FRANKENWALD UDF: PHASE 2: COMMENTS ON DRAFT URBAN DESIGN FRAMEWORK

Submitted on behalf of Frankenwald Development Committee (FDC) by Urban Infinity Consultants

5 February 2021

Map 1: Proposed Nodes in Frankenwald in accordance with Nodal Review. (Source- Frankenwald UDF, fig 22).

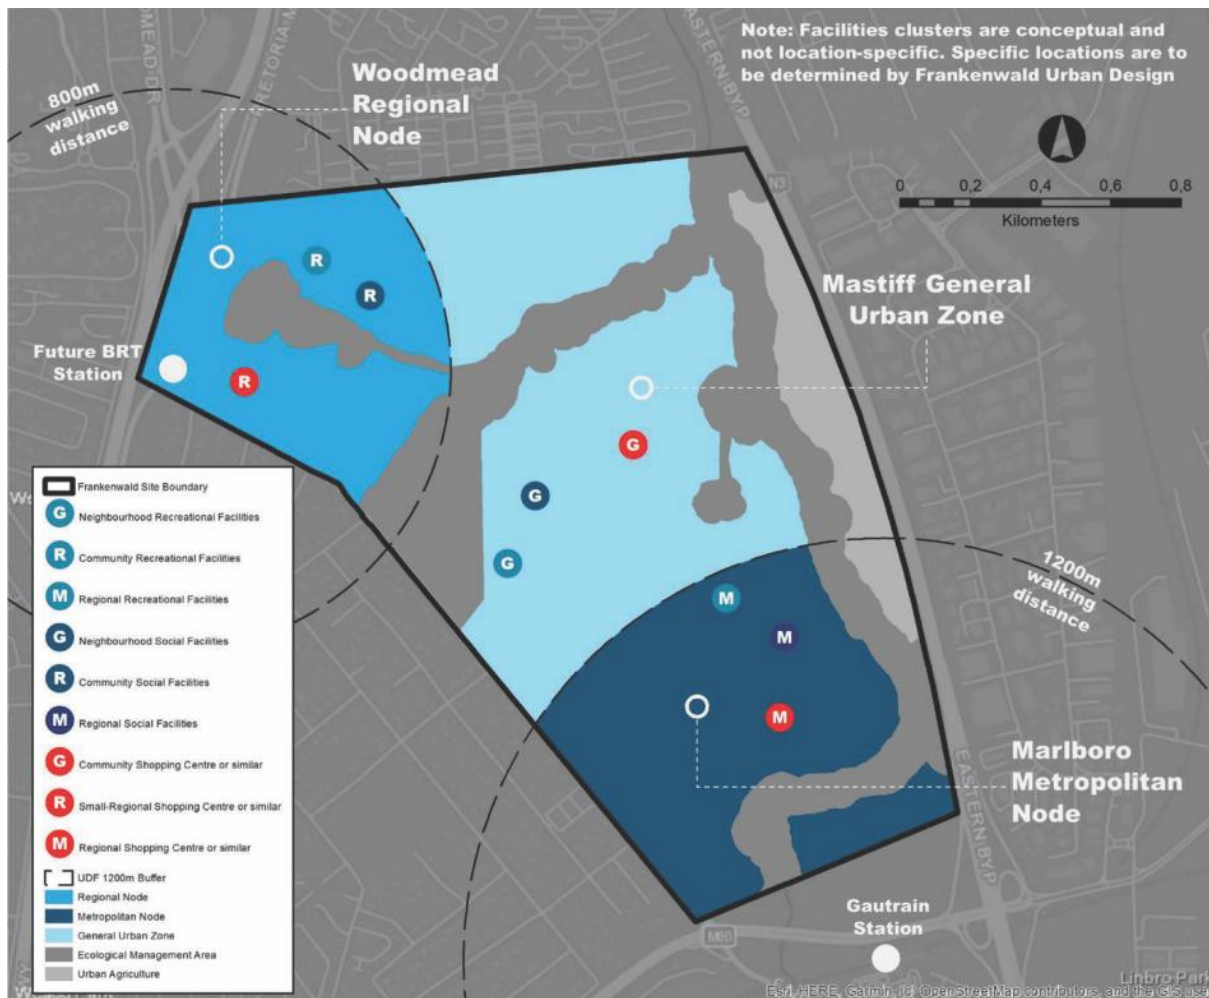
The Johannesburg Nodal review Policy 2020 is used to calculate and propose relevant densities within existing built up areas. As per the Nodal Review, existing developments have been classified and given a nodal character. An important factor to consider is that the surrounding areas fall within nodes that are more suburban in character and have very low densities and height restrictions. Due to the nature of these nodes, owners and developers cannot maximise the development potential of their properties. With the development of Frankenwald a question arises as to whether such allowances will be given to the existing surrounding areas. Along with this, the nodal review makes specific reference to account for surrounding areas. As per the proposed general urban zone on Frankenwald, the neighbourhoods Kelvin and Buccleuch have been considered to some extent however the density relationship does still not create a transition from one area to the next. Since Kelvin and Buccleuch are predominantly suburban areas, the maximum height would be 2 storeys whereas the UDF makes

reference to 5 storeys as the maximum. It is of interest to surrounding land owners that the heights be adjusted to the minimum within the transition zones so that there is less visual distortion for users.

Map 2: Proposed Housing Densities in Frankenwald. (Source- Frankenwald UDF, fig 23).

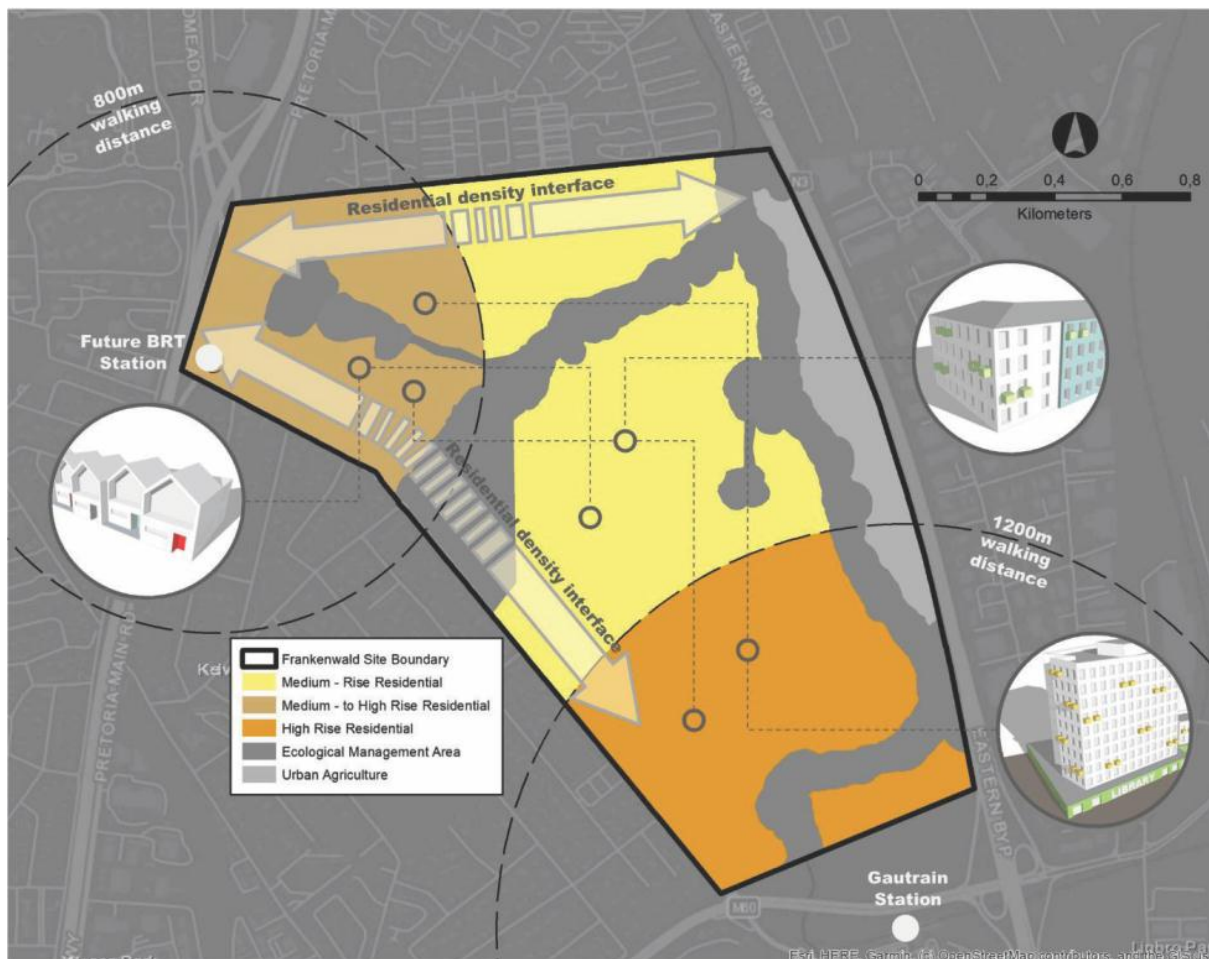
- All fully subsidized housing should not be built with typologies that can allow backyard shacks/ Shack Farming.
- It would be preferred that bonded and rental units be situated closer to the existing suburban areas so that these may add to the rates base instead of taking from it as these ownership types are generally better well-kept than fully subsidised units who generally fall into disrepair due to body corporate failure or lack thereof.

- Densities should be minimally increased from the existing densities within the interface zones.
- All buildings that are proposed should take into account architectural styles of the surroundings.

- Edge conditions should be carefully looked at so that the development is inclusive of surrounding areas rather than shutting them out.
- Facilities, services and amenities should be looked at in greater detail for surrounding areas.

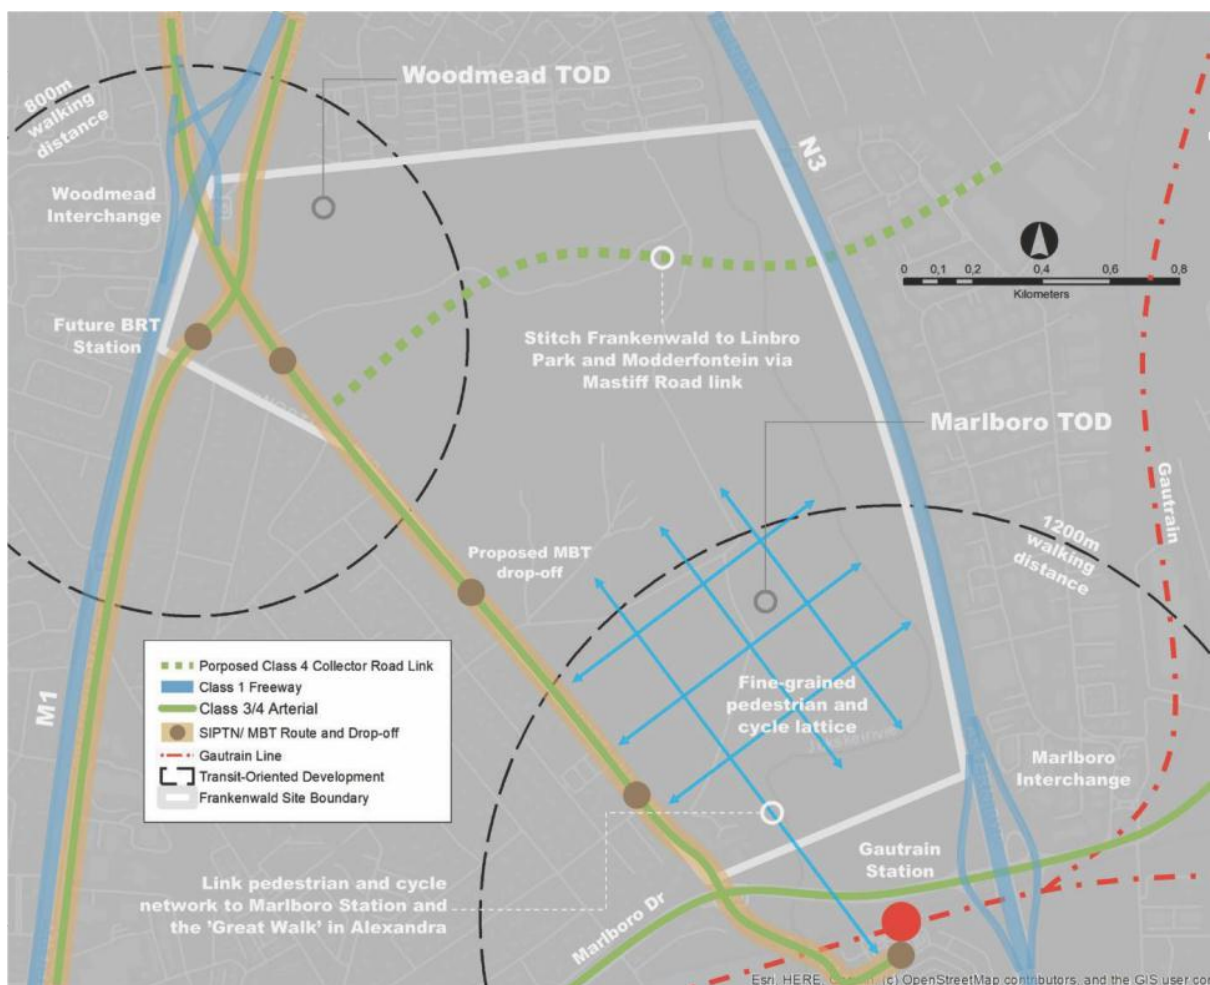
Zone 7 is adequately placed along Mastiff road and seems to be an extension of the Frankenwald industrial park across the highway. Light industrial/Commercial/Logistics is welcomed in this particular zone.
